SUBJECT: Forwards responses to draft SER Open Items 172 & 173. Resumes of personnel to fill positions of environ & radiation control manager & radiation control supervisor will be added to FSAR when positions filled.

SHEARON HARRIS NUCLEAR POWER PLANT  
UNIT NOS. 1 AND 2  
DOCKET NOS. 50-400 AND 50-401  
DRAFT SAFETY EVALUATION REPORT RESPONSES  
RADIOLOGICAL ASSESSMENT BRANCH

Shearon Harris Nuclear Power Plant (SHNPP)  
Draft Safety Evaluation Report (DSEER)  
Radiological Assessment Branch  
Open Item 172 (DSEER Section 12.5.1, Page 12-13)

FIGURE 6.2.1-1

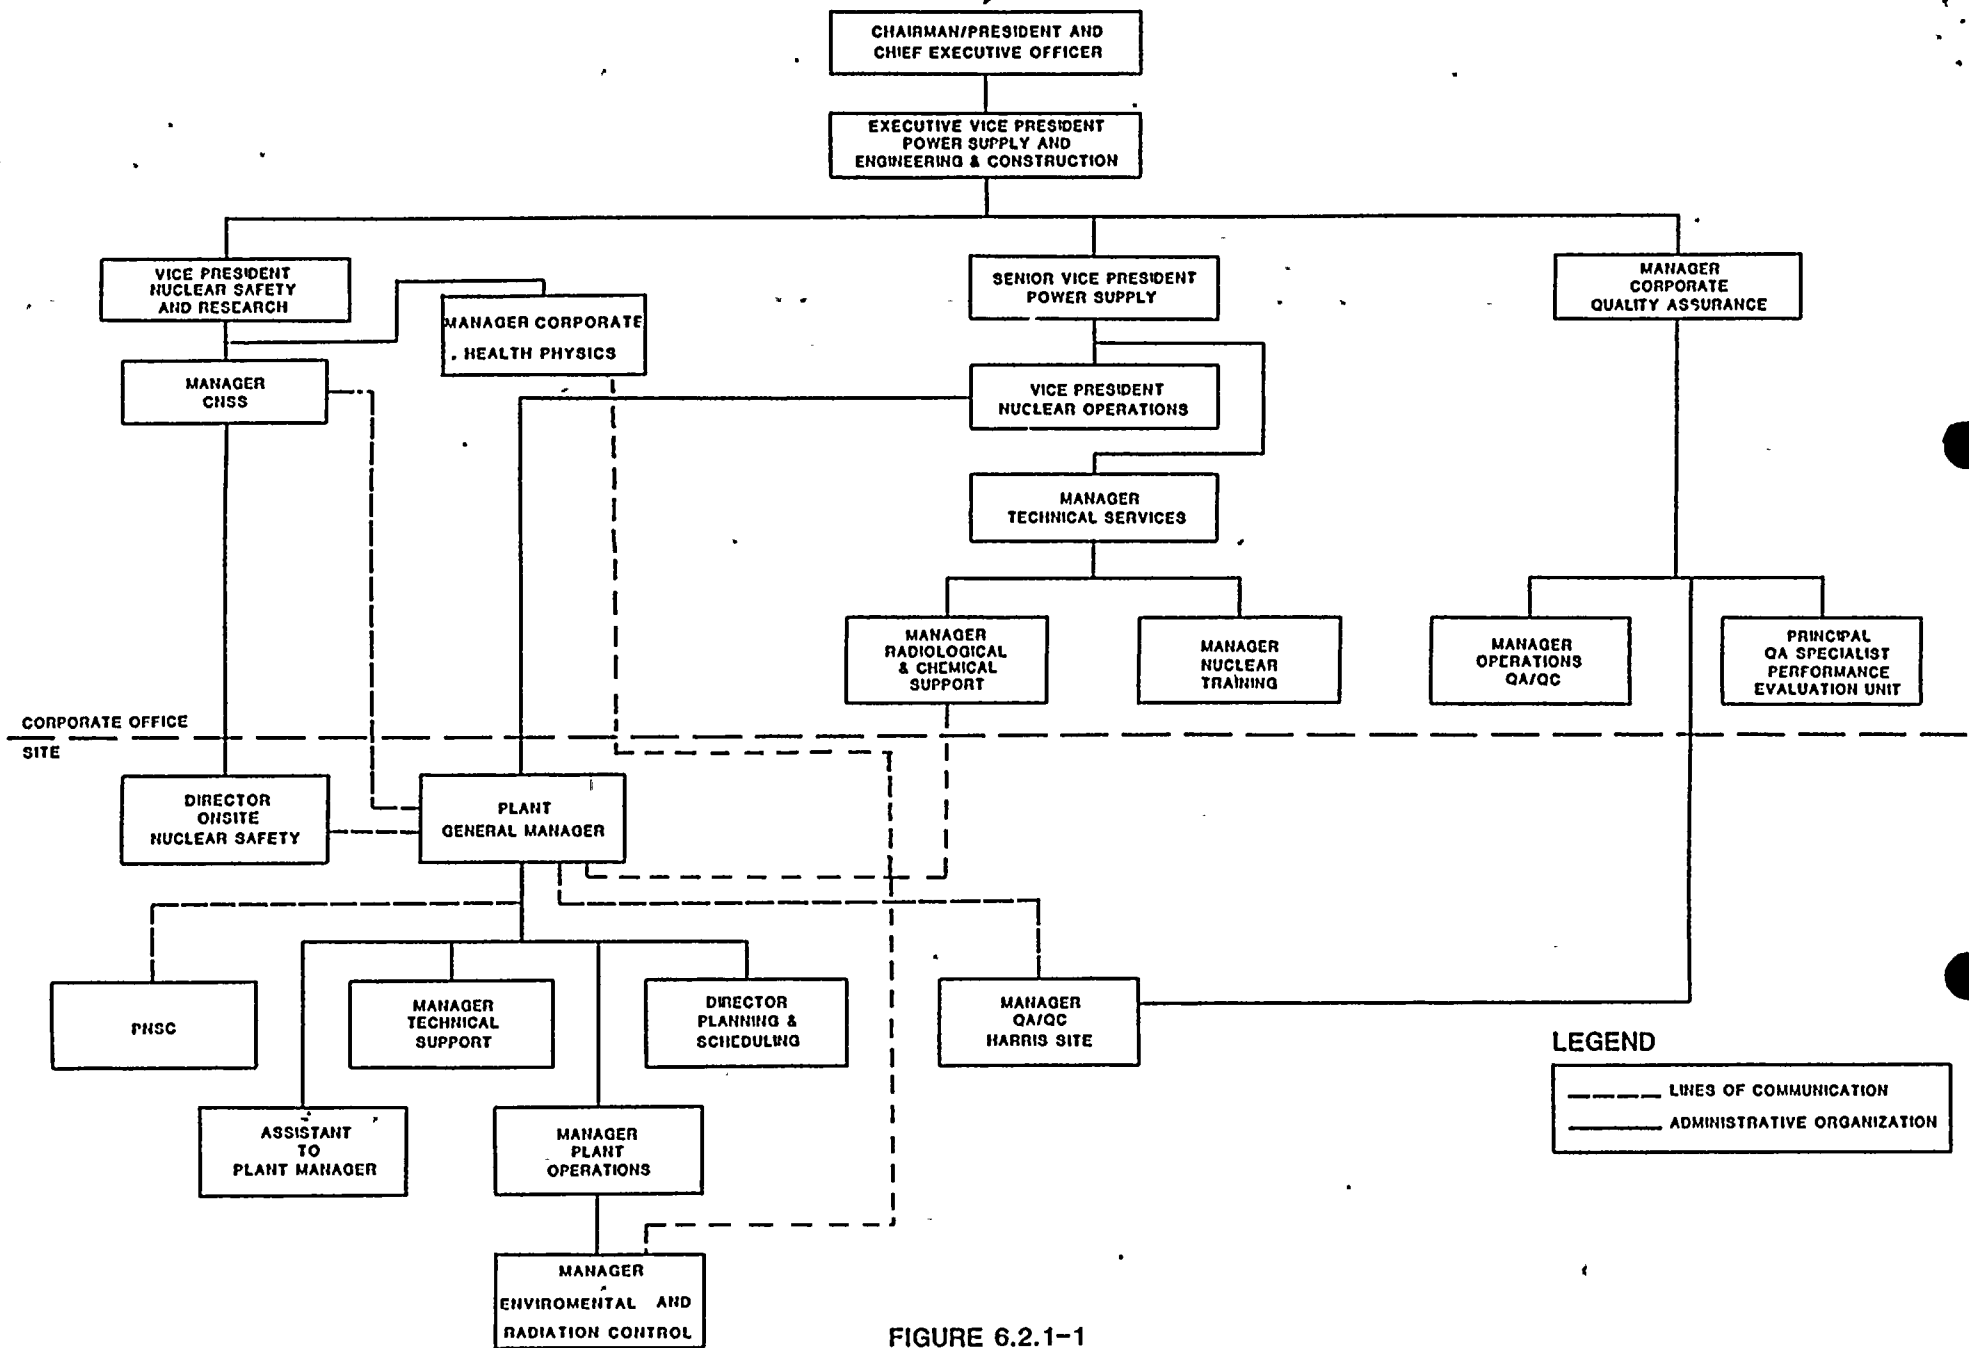
The Harris plant organization chart shows the Environmental and Radiation Control Manager reporting to the Manager, Plant Operations. It is the staff's position that in matters relating to radiological health and safety, the individual responsible for the radiation protection support group's activities has direct responsibility to both employees and management. This responsibility can best be fulfilled if the Environmental and Radiation Control Manager not only has access to the General Plant Manager, but also is independent of the plant operations management, whose prime responsibility is continuity or improvement of station operability. This apparent lack of independence is also an open item.

As indicated in the draft Technical Specifications, Section 6, Figure 6.2.1-1, Offsite Organization (attached), the Manager - Environmental & Radiation Control has direct and open lines of communication with the Plant General Manager, Manager - Corporate Health Physics, and the Manager - Radiological & Chemical Support for matters regarding the radiological health and safety of employees and the public. The Manager - Environmental & Radiation Control is charged with the responsibility and is encouraged to use these lines of communications to ensure the company policy for Health Physics and ALARA are implemented.

Carolina Power & Light Company feels that the current organization meets the intent of NRC's guidance, since the Manager - E&RC does not report to the Manager - Operations or Manager - Maintenance but reports to the next level of management, the Manager - Plant Operations. This organization includes the additional check and balance of encouraging the Manager - E&RC to communicate directly to the Plant General Manager and Corporate Managers in Health Physics matters and unresolved concerns.
